HOR. SCALE 1"=100'		BOOK 1071	PAGE 65
VER SCALE 1"=2'		DATE 11-25-41

DEPARTMENT OF PUBLIC WORKS DETROIT

STREET PAVING PLAN

NAME OF STREET LAPPIN

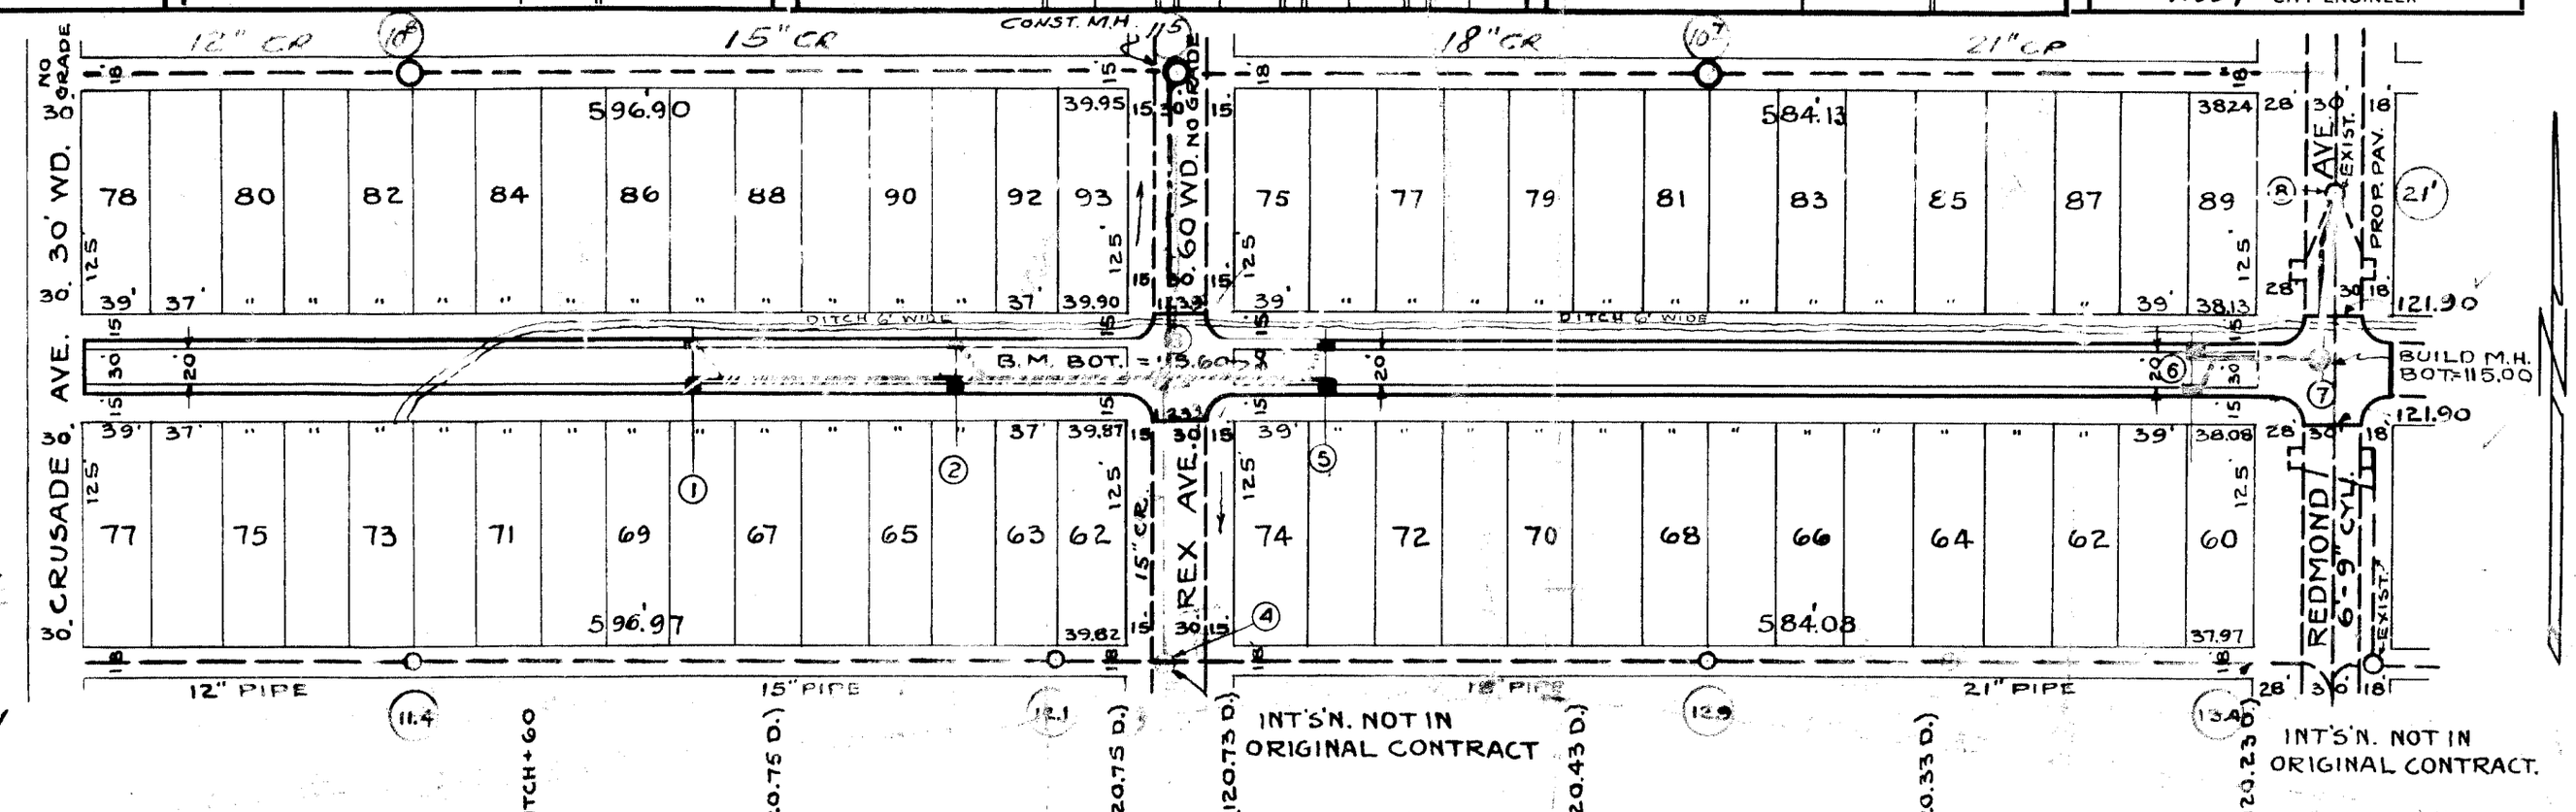
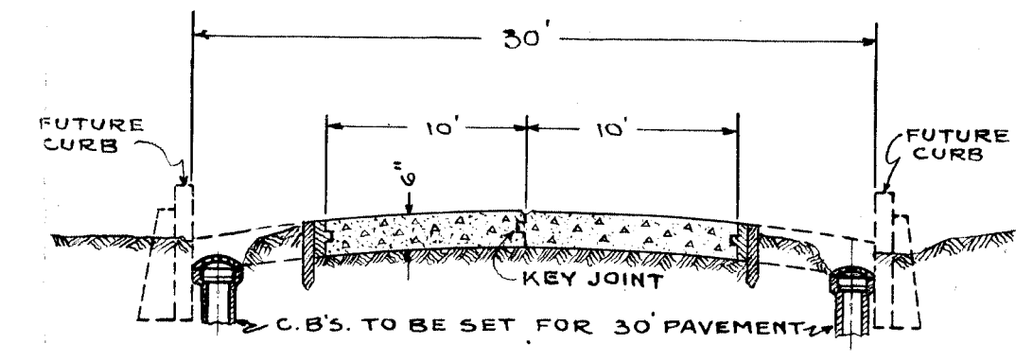
SEWER			
INDEXED			
REVISIONS			
8/2/42 Establish New Grade			
3/26/42 - REVISED DRAINAGE			
SEE NOTE.

NOTE: 3-26-42
CHANGE OF DRAINAGE CONST.
OUTLET IN REX TO DRAIN NORTHERLY TO EXISTING M.H. AT ALLEY NORTH of LAPPIN.
